SERVICE BULLETIN NO. 516 - Piper

Fuel Cell Vent System Modification

PA-24 and PA-24 "250" Comanche

SKETCH

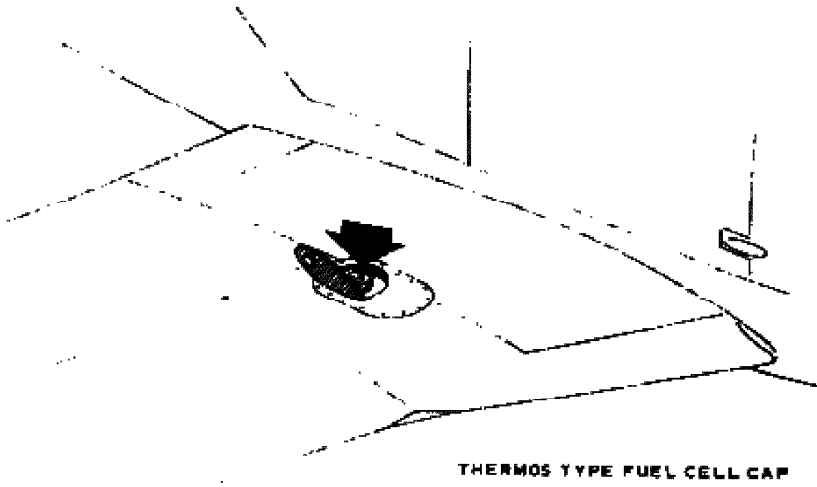
To provide the necessary material and instructions to accomplish installation of an improved fuel cell venting system incorporating recessed NACA type anti-icing fuel cell vents which will minimize the possibility of fuel cell vent restriction resulting in fuel cell collapse. (See lower portion of sketch below this letter.)

(2) Above referenced aircraft serial numbers 24-1 to 24-580 incl. must order, in addition to modification kit number 760 277, "thermos" type fuel cell caps, Piper part number 21821-00, inasmuch as this item is not included in Kit No. 760 277. (See upper portion of sketch, below.)
